# construction bid document addendum 01

project: Southern Maine Community College - Horticulture Greenhouse  
Midcoast Campus, Brunswick, Maine BGS # 3674

date: 12 November 2024

20 SECTION  
3/16"=1'-0" LOOKING NORTH

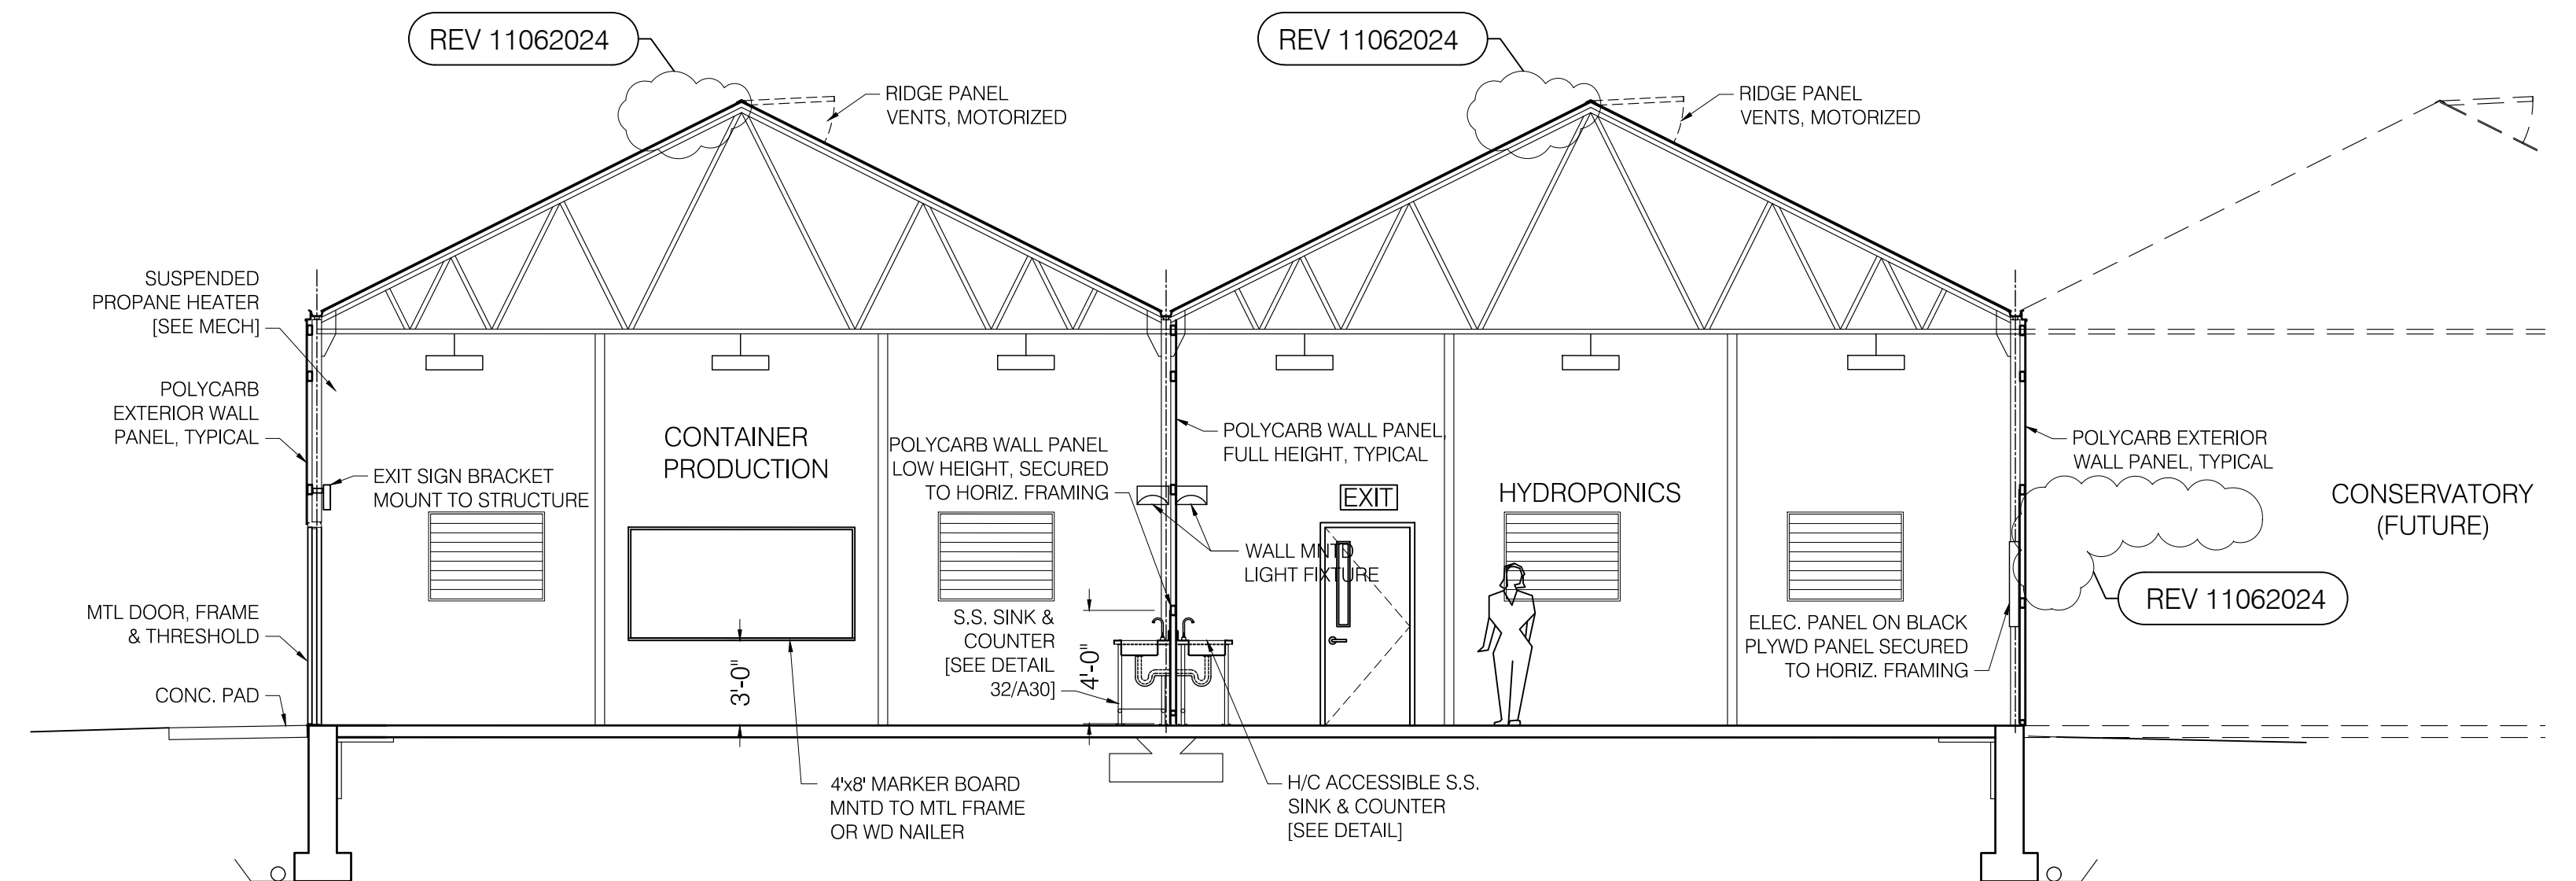
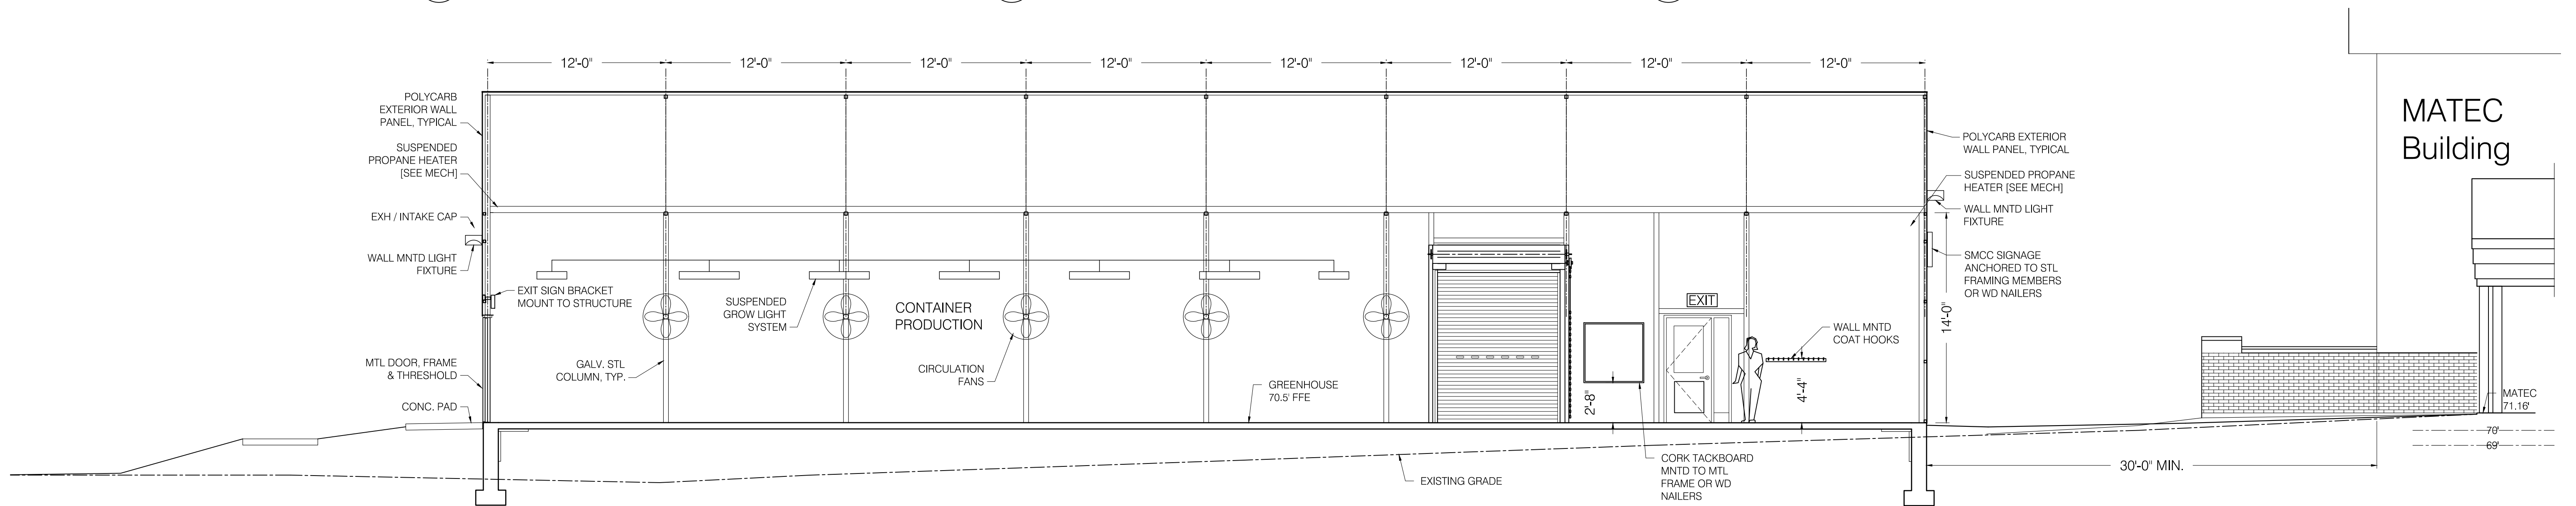
A20 EXTERIOR ELEVATIONS: Wall ventilation removed, ridge ventilation revised and exhaust fans and dampers revised.
